Proposal for Paragraph 4.5 < Markings >

⟨ Survey concerning Markings ⟩

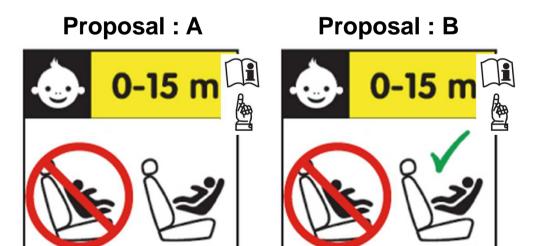
Users of Type-3 (Forward-only facing CRS) may be confused have a label which has a tick on non-existing installation direction.

Users of Type-5 (Lateral, Rearward and Forward facing CRS) may be misunderstand that Lateral Facing installation is NOT allowed.

Proposal: 1 There will be 2 different descriptions of "DO NOT" in one CRS. It is better to unify in one description.

In the case of Child Restraint Systems that can be used forward facing, it shall have the following label permanently attached and visible to someone installing a child restraint in the vehicle (the information shown is a minimum. Supplement can be added in the label if necessary. Language should be spoken language of the region where product is to be sold):
